Annex I
Summary of the Environmental Impact Assessment (EIA) Process
June 2026

1.1 General background and changes to the project

2.2 Addendum to the EIA Report

Figure 13 – Sun path study – shadow cast in December around 13:00 (*Source: Addendum to EIA Report*).

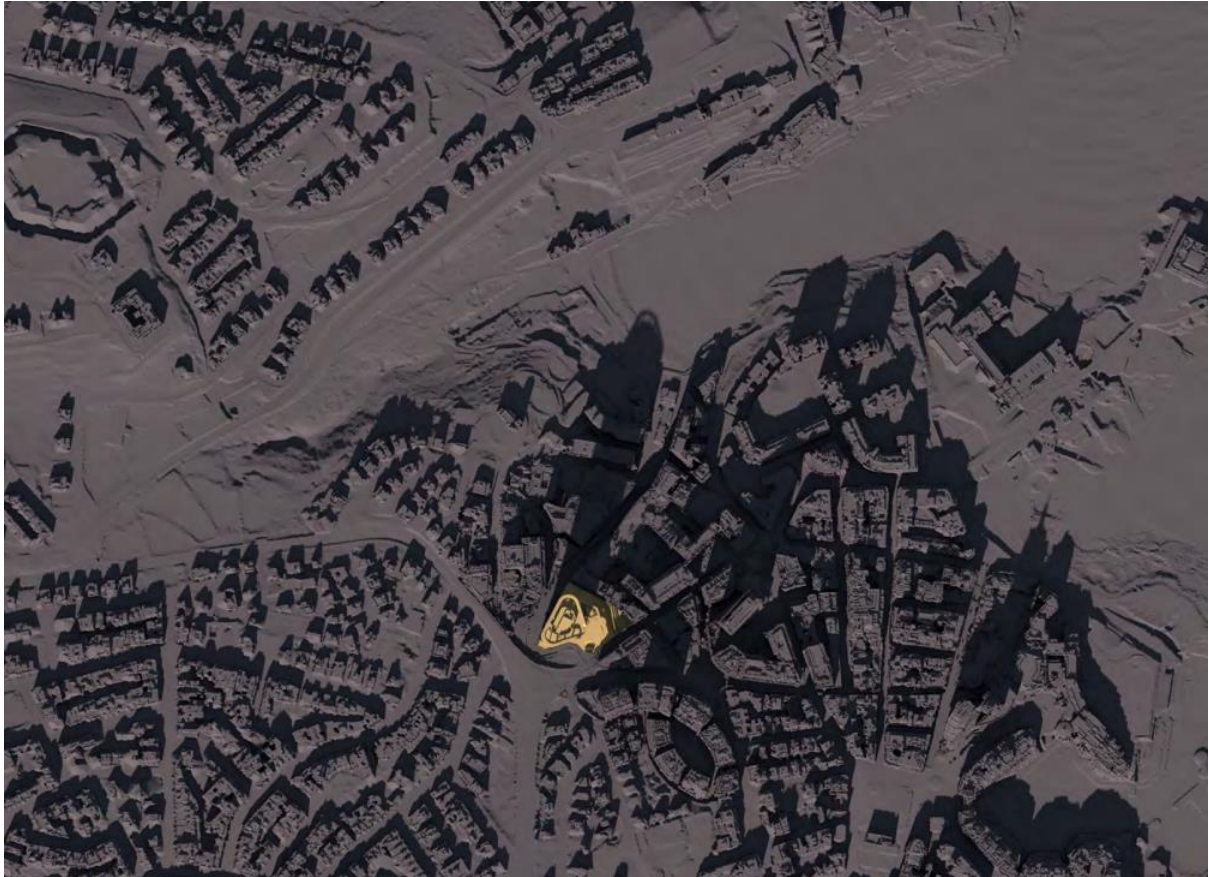
Comment
The second problem concerns the shadowing effect on residential areas off Swieqi which the proposed development will create. The Swieqi Local Council is only concerned with then effect on its residential areas, although it recognises that the shadowing effect on parts of St Julians / Paceville and on commercial areas even in Swieqi will also be significant. The well-being of Swieqi residents is constantly a top priority for the Council. The Council notes that the development being considered proposes an increase in height of just under 33 metres compared to the previous submission, and also an increase in footprint (which clearly affects the width of areas in shadow). Referring to the Solar Path and Shading Evaluation section of the EIA, the Council notes that 1. Early afternoon shadows cast will reach St George's Bay in December afternoon. St George's Bay and Beach is the seaside area most easily accessible to Swieqi residents. This Bay is very much frequented in December by Swieqi residents for pleasant walks along the sea, and the conclusion that this area will be in cold shadow at this time will deprive residents of a privilege which they have so far enjoyed. This would represent a down grade of their quality of life, for the benefit of a commercial development, and is to be objected to. 2. The sunpath analysis shows that Triq I-Gharbiel in Swieqi will be seriously affected by shadowing throughout the year: June 8am to 11am, September 8am to 10am, and March 7am to 10am. In addition, residential areas in Triq il-Migbed and Triq is-Sirk will be in shadow in June between 8am and 10am, Triq in-Nemes in September 10am to 12 am and March 9am to 11am. Although this shadowing is described as "transient" in the report, it is a fact that once more the enjoyment of their properties by residents in these streets will be curtailed. The construction of the tower will represent a gain to the developer but a loss to the residents. This must also be objected to. If the project were to be eventually approved, the Swieqi Local Council requests that environmental compensatory measures be required to be effected by the developer in these areas. Swieqi and its residents cannot continue tolerating the degradation of their quality of life as a direct result of development projects. Planning is primarily for people, the PA and ERA must never forget this.
